**FILE** P. I. No. 0006892, DeKalb County **OFFICE** Preconstruction  
CMQ-0006-00(892)  
Memorial Drive at East Ponce de Leon Avenue  
Intersection Improvements **DATE** September 1, 2006

**SUBJECT** APPROVED PROJECT CONCEPT REPORT

**SUBJECT: CONCEPT REPORT**

PROJECT NUMBER CMQ-0006-00(892), P.I. number 0006892, DeKalb County  
Memorial Drive at East Ponce de Leon Avenue/Main Street

# SITE LOCATION MAP

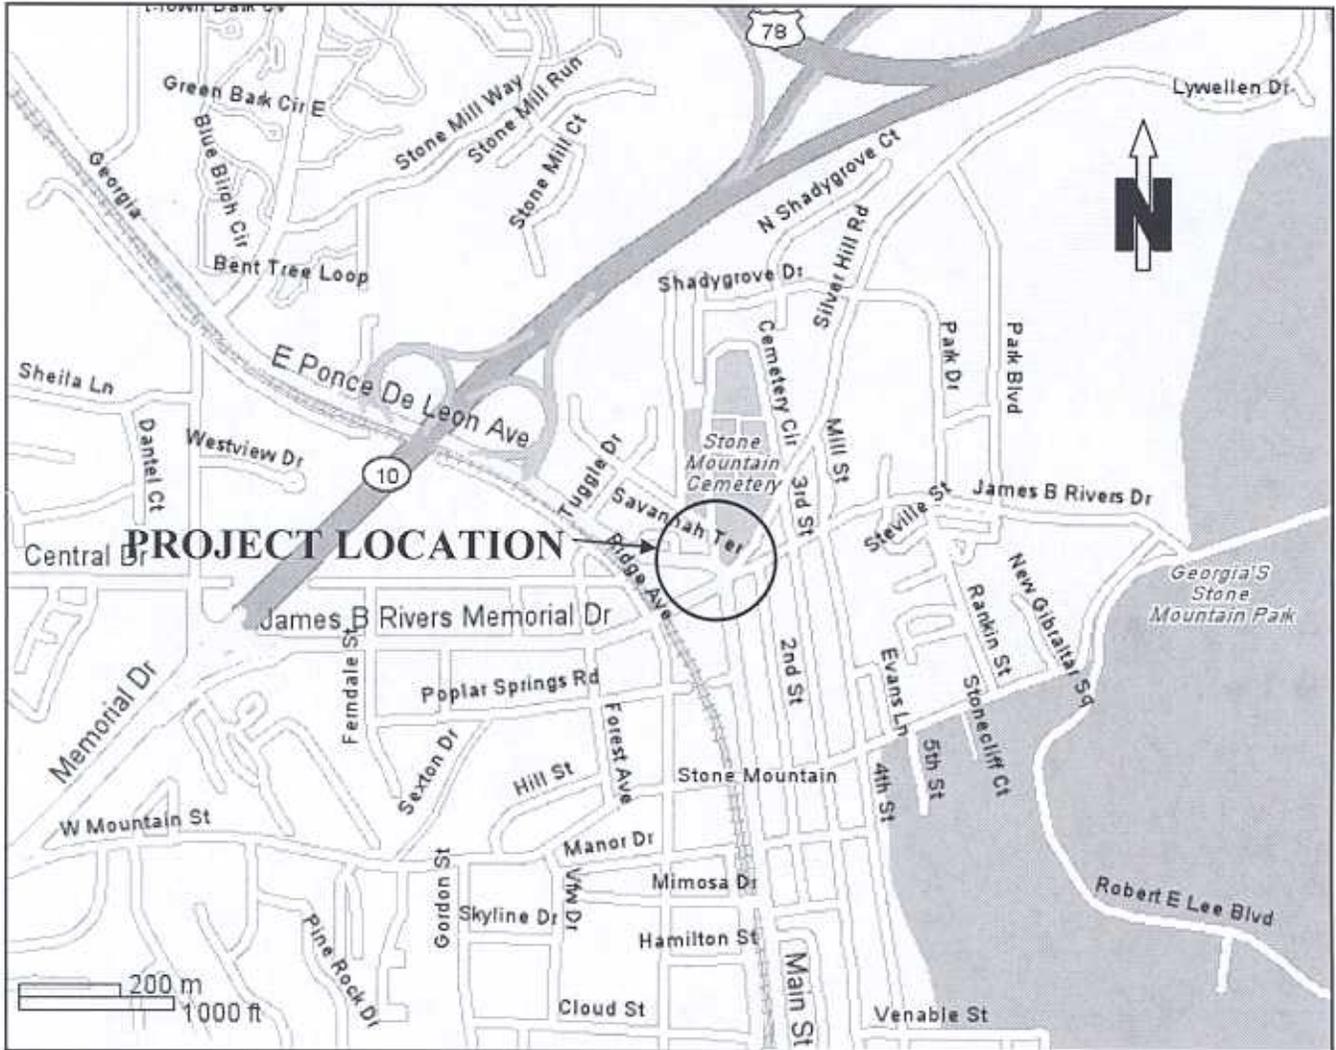
Add a north arrow.
